# information bulletin

## Bourke Road, Clarinda – Proposed speed humps

## Proposed traffic measure adjacent 150 Bourke Road

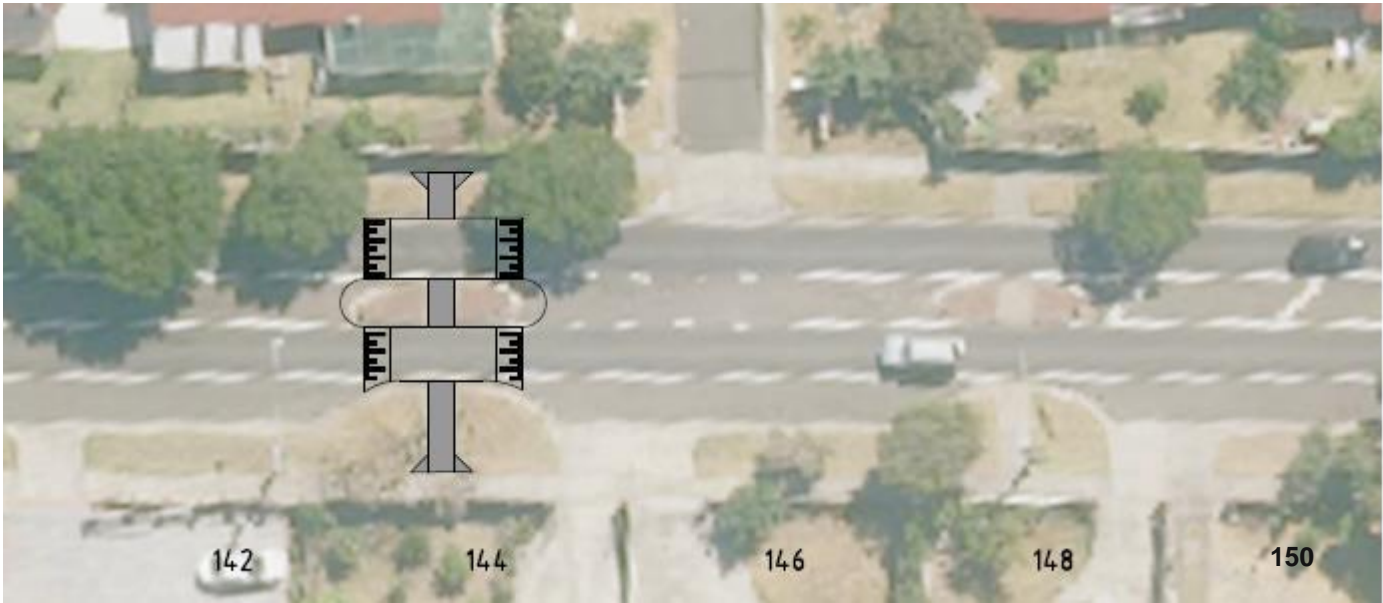
In August, Council wrote to residents regarding the feedback received on proposed traffic calming measures on Bourke Road. The feedback showed strong support from residents for the measures shown in the attached plan. The plan shows four speed humps, including a hump adjacent to 144 Bourke Road and Clarinda Retirement Village. During the detailed design, Council identified drainage issues associated with providing a hump adjacent to number 144.

Consequently, Council is proposing to relocate the hump (with new kerb-buildouts and a pedestrian refuge island) approximately 40m to the east - opposite 150 Bourke Road (see attached plan). The existing kerb outstand and centre island at number 148 Bourke Road will also be removed. Relocating the proposed hump to this new location will remove the need for extensive drainage works.
